Work Order ID 121103

Item Name: Clip

From: Jean-Luc Menard
Sent: November-24-14 7:38 PM
To: Linda Lacelle
Cc: David Duval; Marc Bellavance; Sylvie Boucher; Holly Menard
Subject: FW: 647.4113/647.4112 FLAT PATTERN ERROR
Attachments: 647.4112-4113_Flat_Pattern.pdf

ENGINEERING CHANGE NOTICE NL 04510

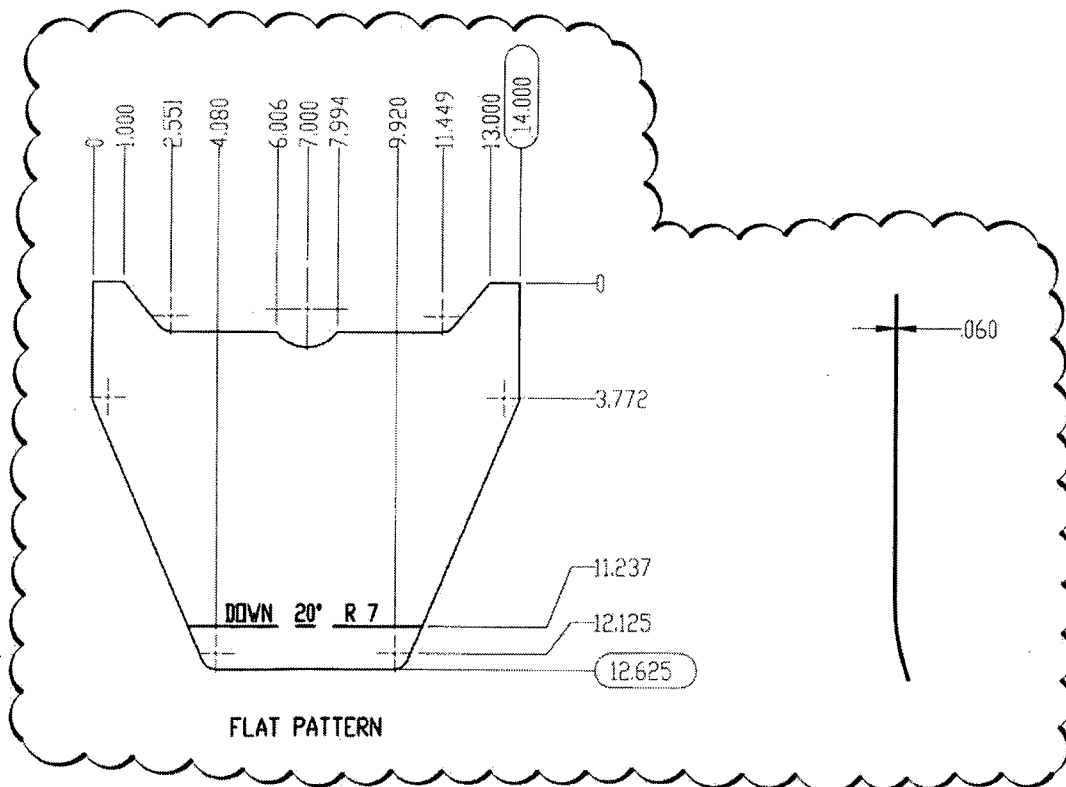
REASON: MODIFIED DOUBLER.

FLAT PATTERN

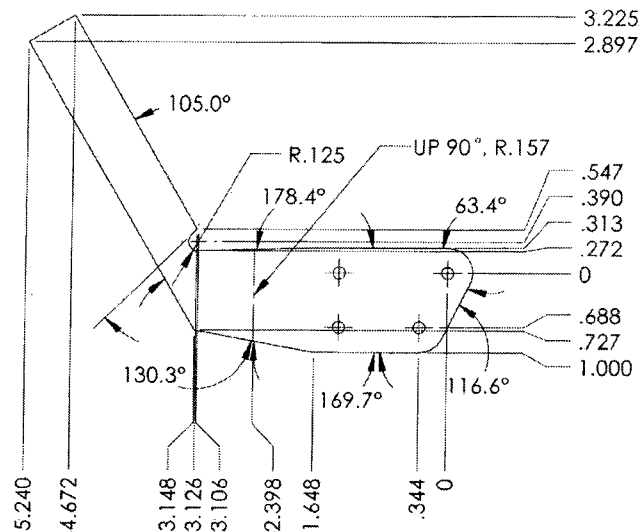
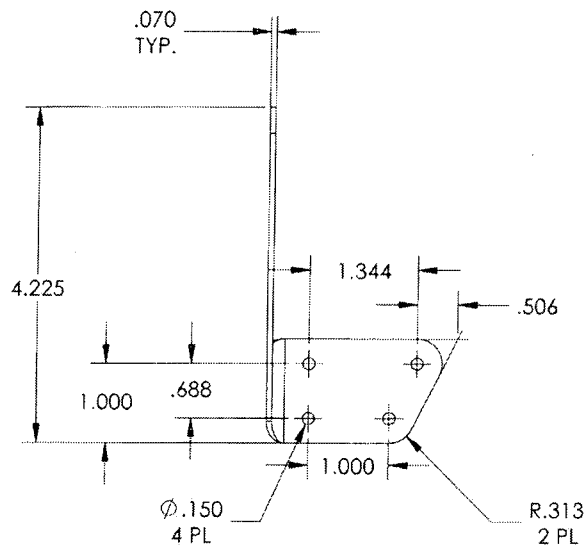
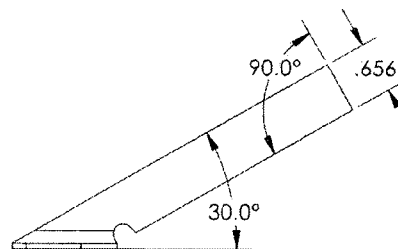
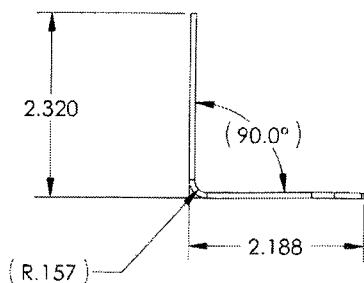
Hi Pablo,
There seems to an error in the flat pattern on the dwg, Marc Bellavance had a quick look and came up with the file attached.
What is happening is the flat pattern is too long in the mid section (see snip below).
Let me know if you need me to issue an ecr for this one, and if we can continue with Marc's updated flat pattern.
If you agree with Marc's pattern, I will attach the email to the w/o so we can continue production.
Let me know,
JL

The flat pattern is acceptable. We'll need to get the drawing updated.
